Re: Stephens Town Crossing Drainage Study -Review #1

DETENTION WORKMAP		
RANGER BRANCH TRIBUTARY 4		
STEPHENS TOWN CROSSING		
CITY OF SANGER, DENTON COUNTY, TEXAS

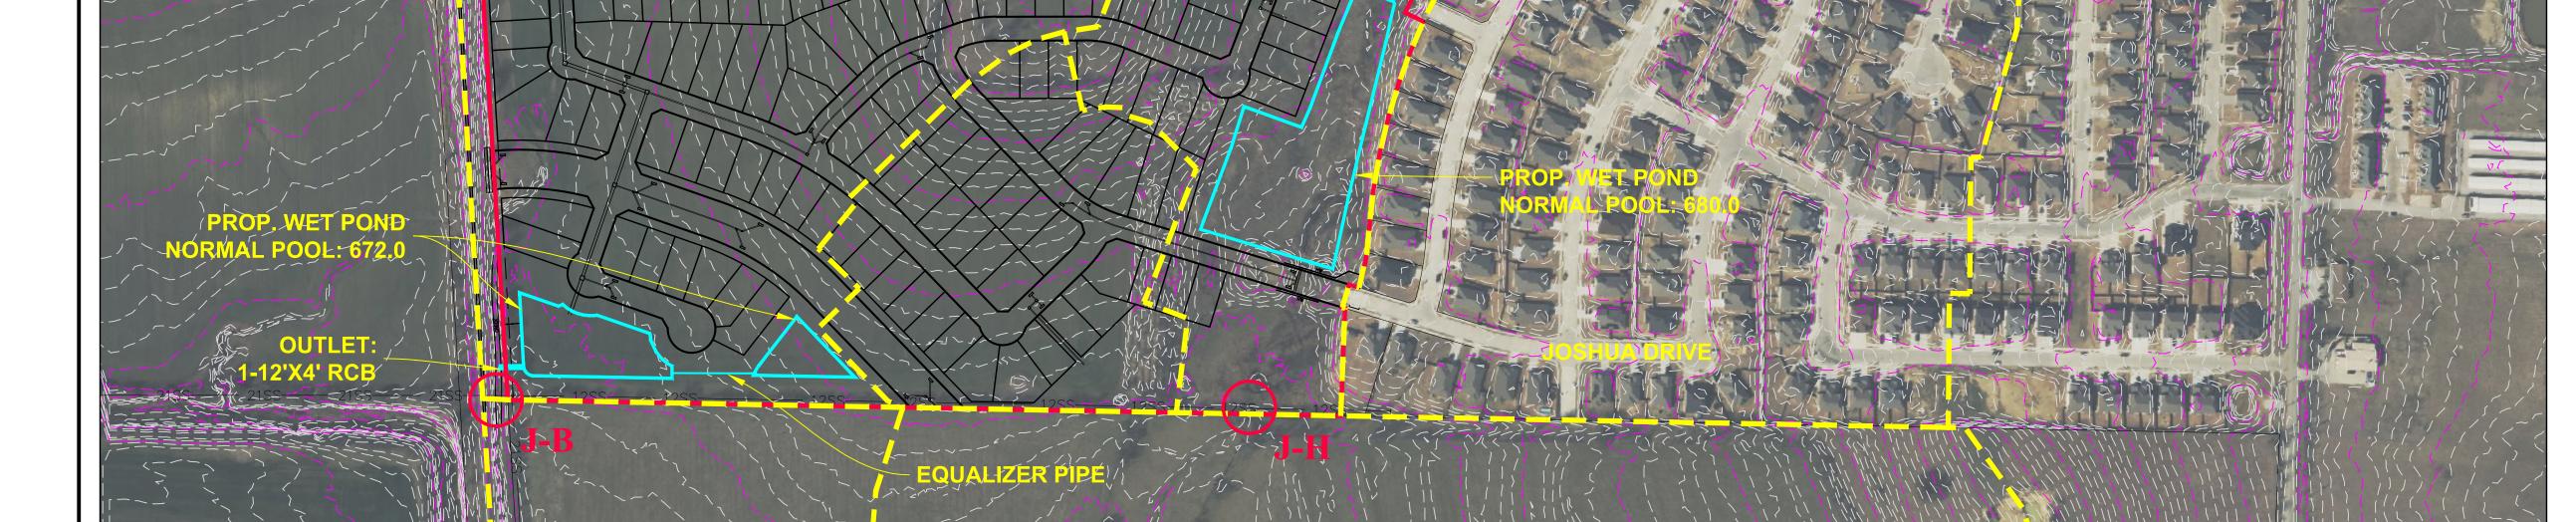
- Please include existing drainage area map and calculations to support results table

Please include proposed drainage area map runoff calculations.Please increase extent of drainage area map to include all drainage areas.

- Please note detention/retention ponds must be designed using the criteria outlined in City of Sanger ordinance 10.106.d.10. Provide supporting documentation to prove criteria is being met.
